TOWN OF ENFIELD
JOHN F. KENNEDY MIDDLE SCHOOL TECHNOLOGY EQUIPMENT
ADDENDUM #2

PROJECT **DATE ISSUED: January 11, 2021**
John F. Kennedy Middle School Renovations
155 Raffia Road
Enfield, CT 06082

D. Narrative of Drawing Changes

The following is a list of changes included in the JFK Middle School Technology Package Phase 3 drawings **Revision "1" 01/11/2021.**

E131 Media Center

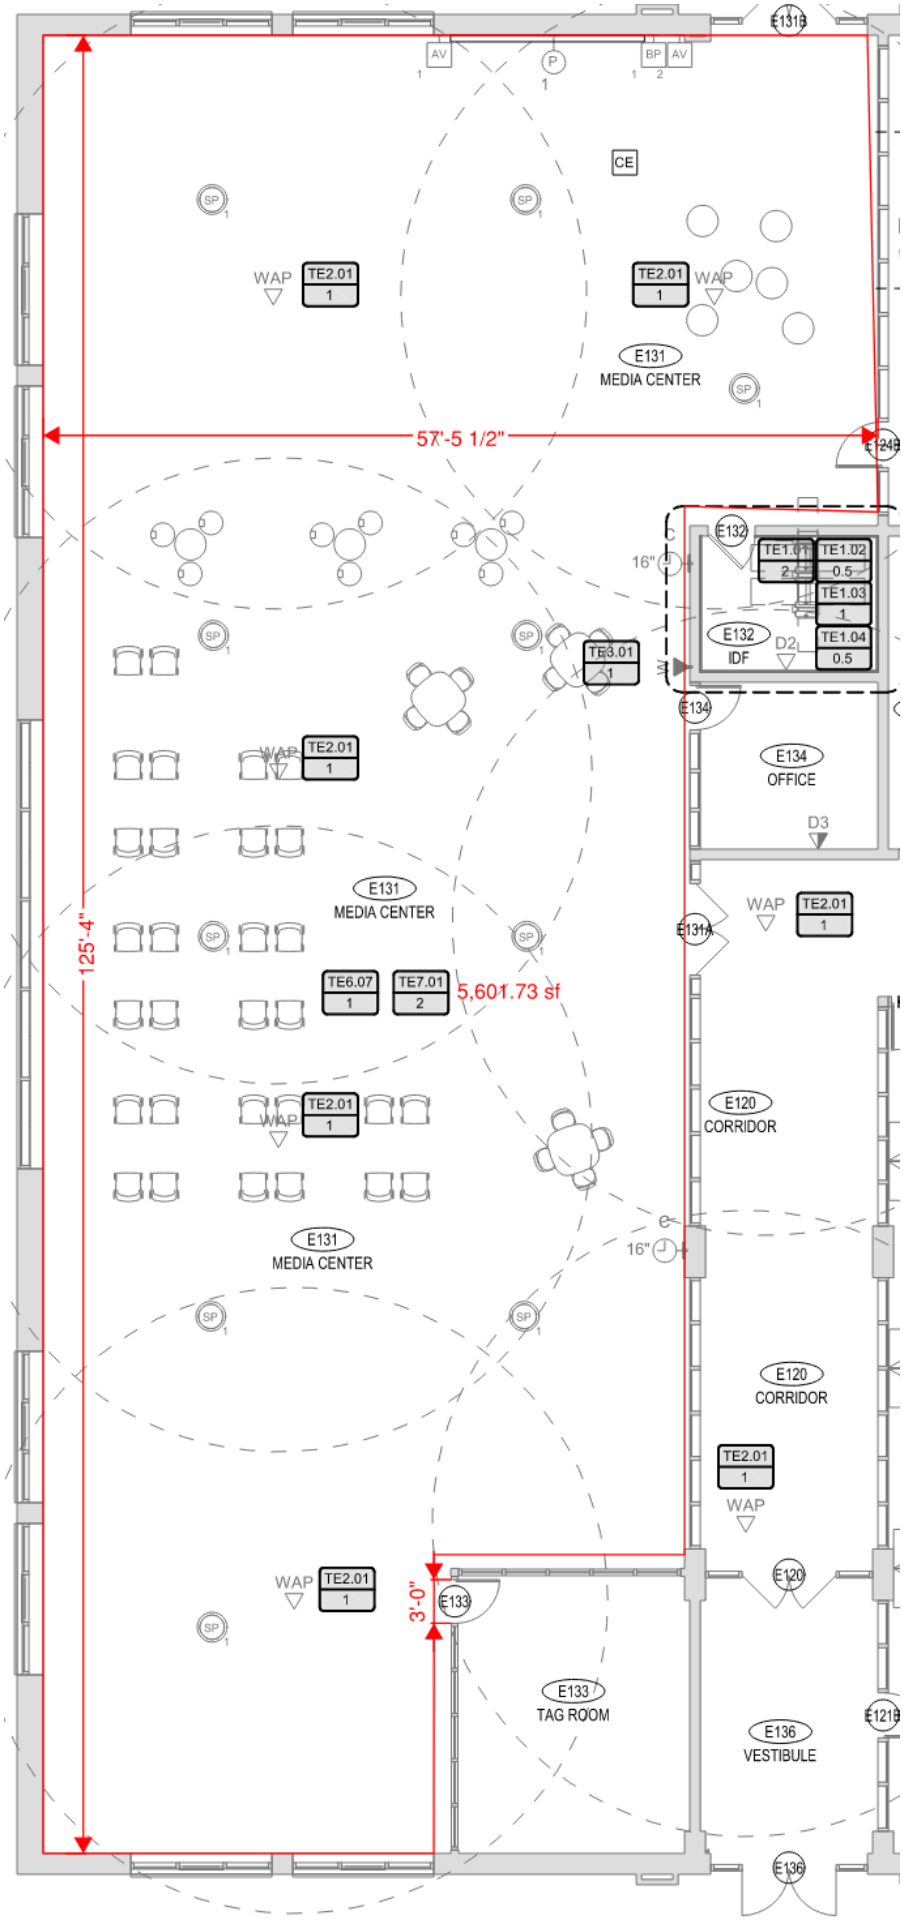
1. Can you confirm what the 5 pairs of Extron speakers in the Media Center will be tapped at?
2. And how large of a space is that?
3. We saw the JBL EON610 speakers which appear to be wireless/Bluetooth speakers….are they part of a separate system?

1. The Media Center speakers would be tapped at 16W since that is the highest level they can be tapped at for 70V and the amp has 200W out providing plenty of headspace.
2. The Media Center is approximately 5,602 SF, using Bluebeam for an estimate. Please review the sketch below.
3. The EON Bluetooth speakers are portable speakers to be used independently from the rest of the system, to be stored in the Media Center along with related equipment.

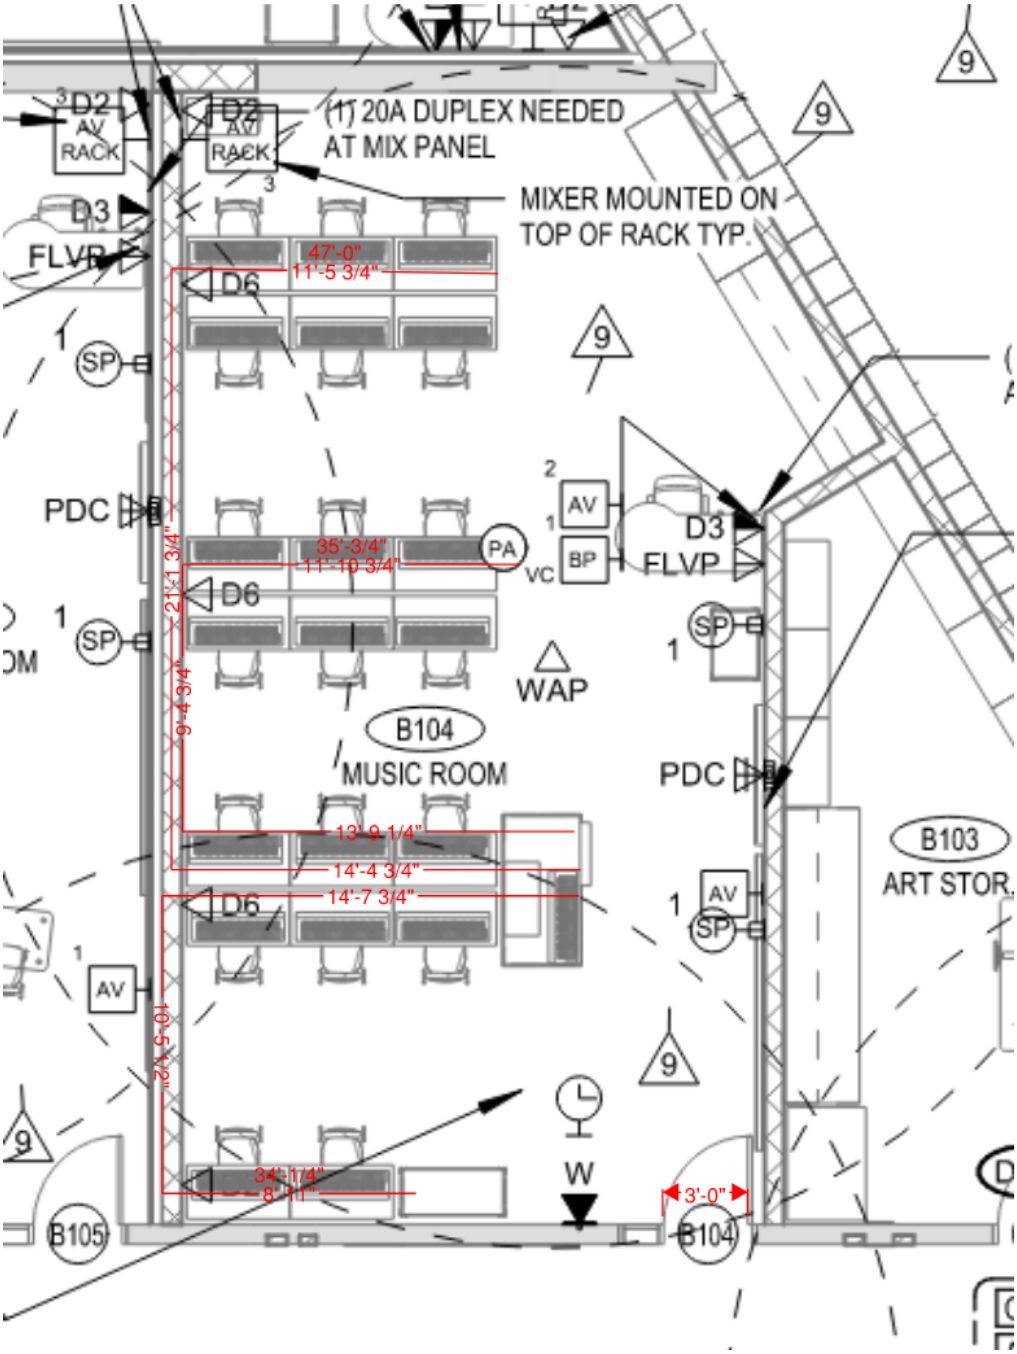
Bid Package #4 – Digital Keyboards - What is the furthest distance for the students from the teacher's lab controller in this room? The cables are a standard 10 Meters (about 31 ft.) Each Keyboard will need a cable run back to the Controller on the Teacher Station.

14 runs will be over 30', so 14 Yamaha LC20 MS RJ45 Lab Connector cables – 20 Meters (60') will be added to the Bid List. The addition of Wiremold 4"H x 2"D for wire management by the Electrical Contractor on the Plan West wall will be requested.
